**ADDENDUM NO. 1**

Pepperrell Cove Town Landing Boating Infrastructure Grant; Town of Kittery, Maine

WIN #018391.14; BDC No. 12040

From: Baker Design Consultants  
7 Spruce Road  
Freeport, ME 04032

SK-2

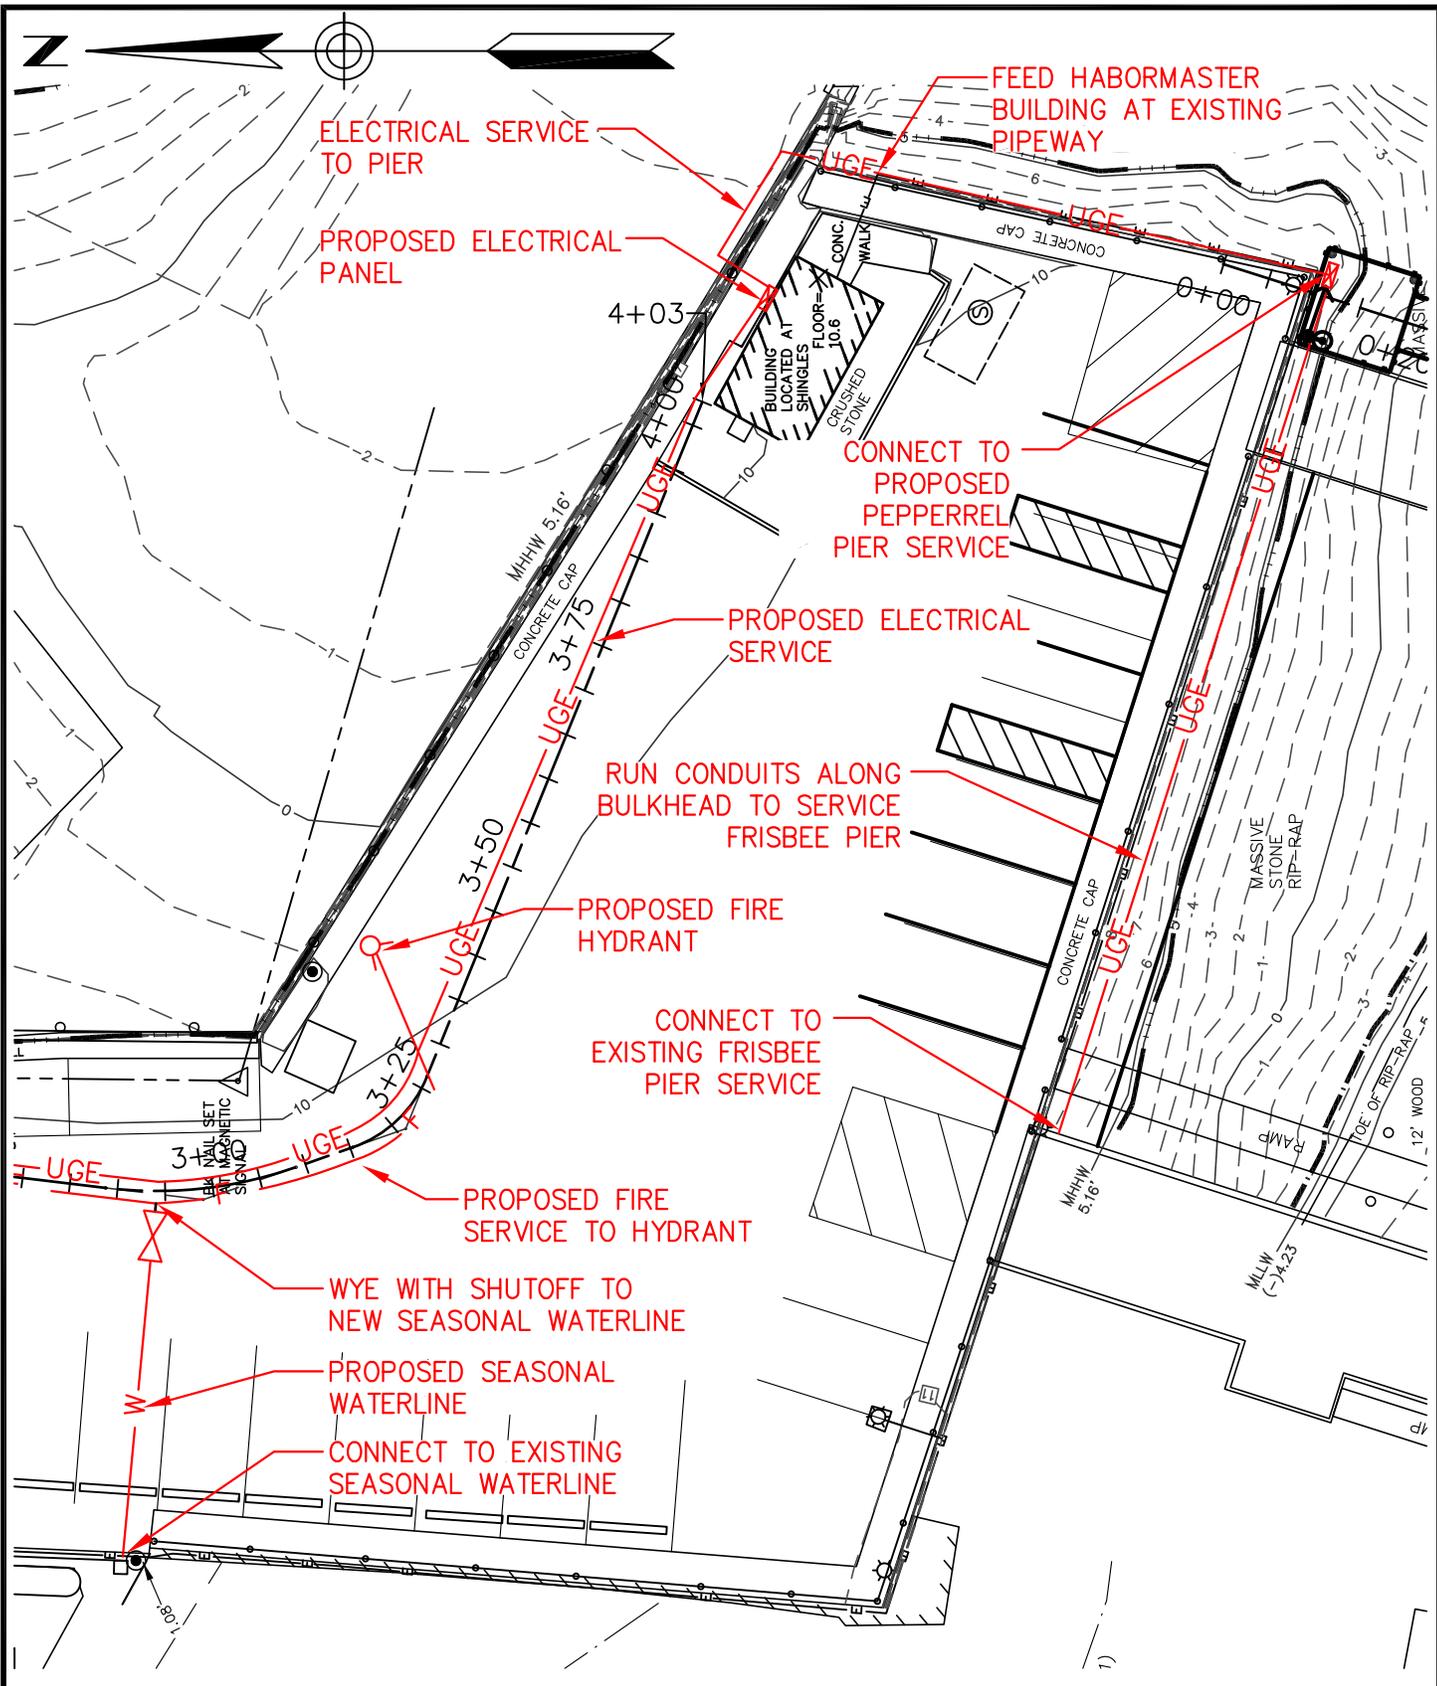
- a. Subsection 1.03 SCHEDULE OF BID ITEMS; B. Alternate Bid Items. **Change** Bid Item descriptions as follows to be consistent with the attached *SK-1 – Addendum No. 1 Utilities Plan* and *SK-2 – Addendum No. 1 Utility Schedule*.

- a. **Substitute** Pier Head Utility Plan and Utility Schedule modifications per attached *SK-1 – Addendum No. 1 Utilities Plan* and *SK-2 – Addendum No. 1 Utility Schedule*. Revision summary follows:
  - Bid Item 13- Underground Utilities; Route **extended** by 10-ft to new Panel and Meter mounted **added** to the exterior of the Harbor Master Building.
  - Bid Item 14- Seasonal Water; Route **reduced** by 40-ft to tie into existing bulkhead mounted waterline Sta. 2+90.
  - Bid Item 15- Fire Hydrant **relocated**; Fire service route **reduced** by 70-ft. Year-round Water Service **changed** to seasonal connection from fire service at 3+90.
  - Bid Item 16-Surface Mounted services to Pepperrell Pier and Frisbee Pier from new Panel **changed** to 75-ft and 170-ft respectively.
